NOTICE OF ENVIRONMENTAL REVIEW PERIOD

APPLICATION NO.: 07-0140

Environmental Review Initial Study

Application Number: **07-0140**

A-3	DATE	01/11/07
	BY	REB
	SCALE	1" = 20'-0"
	PROJECT	WINE PRODUCTION BUILDING

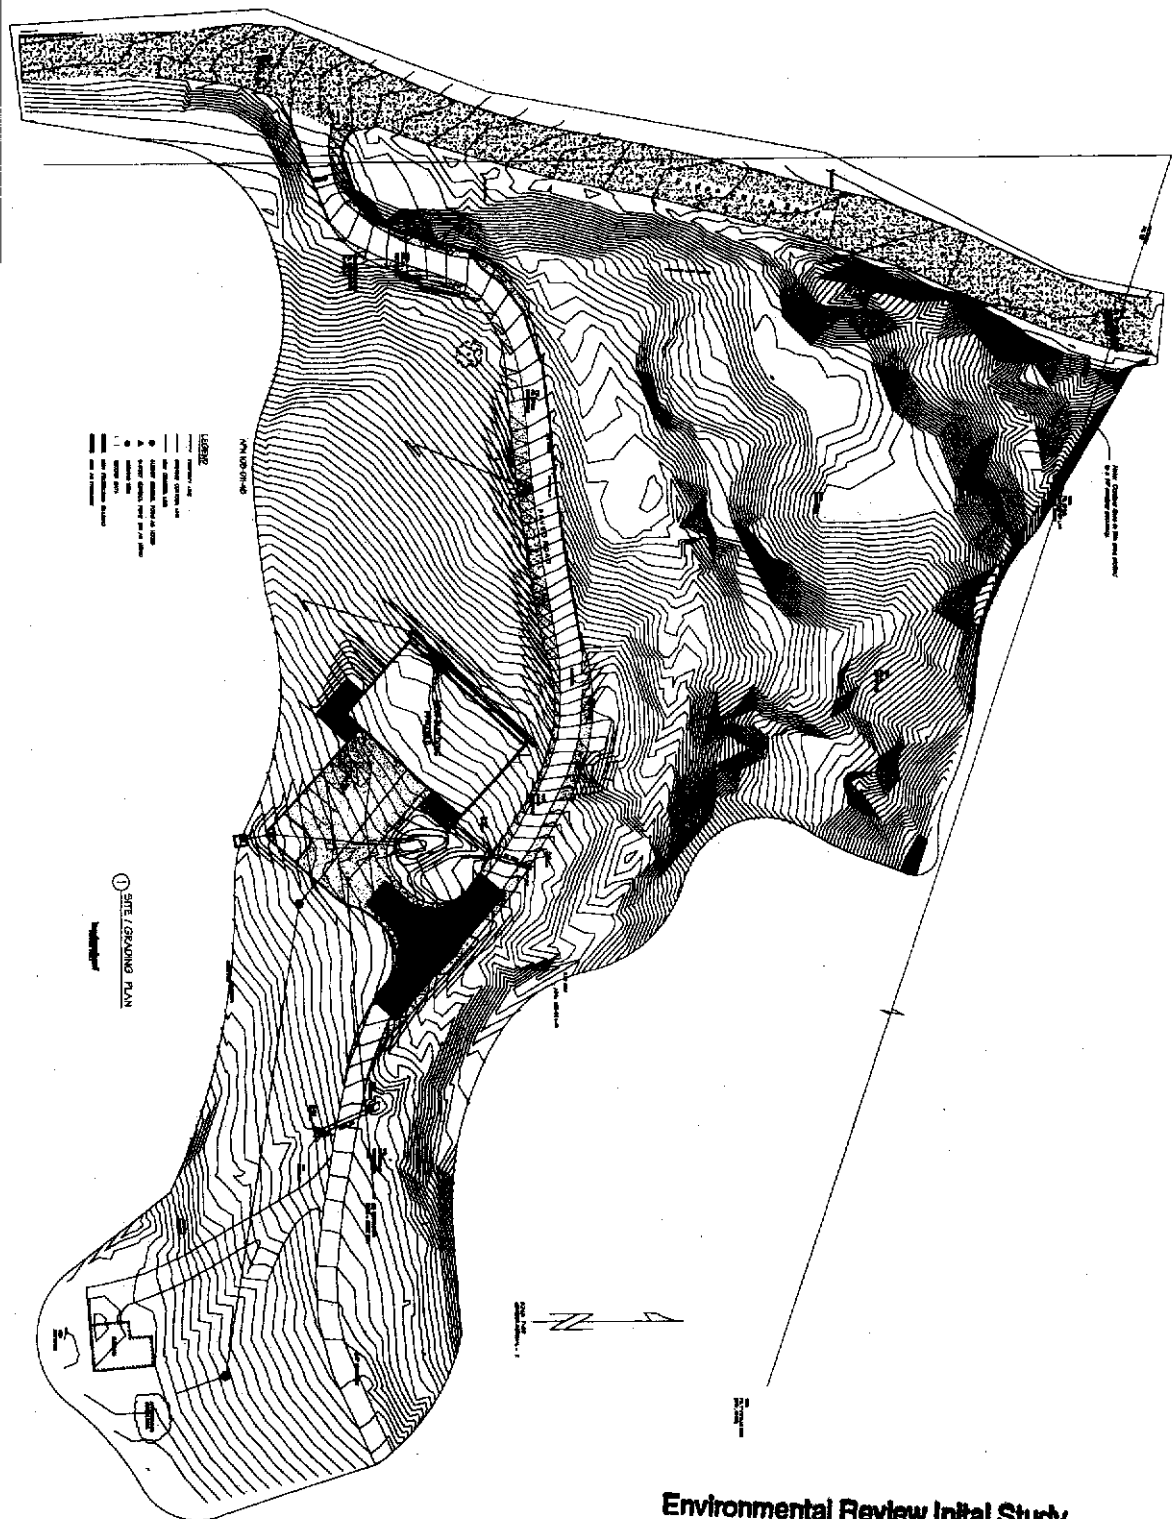
- 1) Please clarify the extent of proposed impervious area associated with the project. What is the extent of the driveway widening? Sheet A-3 shows widening for a section, how will this widened section tie into the existing driveway and road?
